Product Change Notification

PCN26-47 - K12 Series – Packaging update for K12GO

Design evolution:

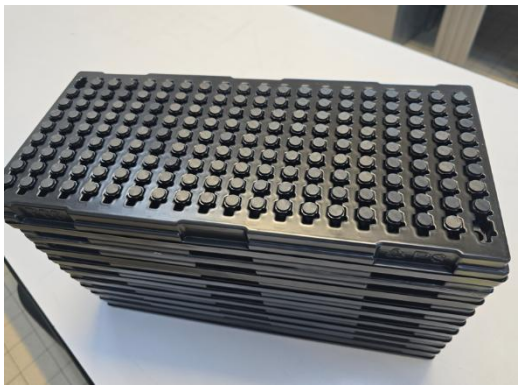
Packaging updated from bulk to tray.

Old packaging in Bulk:
250 pcs in plastic bag / small carton_ 150x95x95 mm
32 small cartons / Carton so **8000 pcs** / Carton 385x385x330 mm
Weight: 11 kg / carton

New Packaging in Tray:
178 pcs / trays _ 410*250*30 mm
10 trays / Carton so **1780 pcs** / Carton 410*250*200
Weight: 3.5 kg / carton
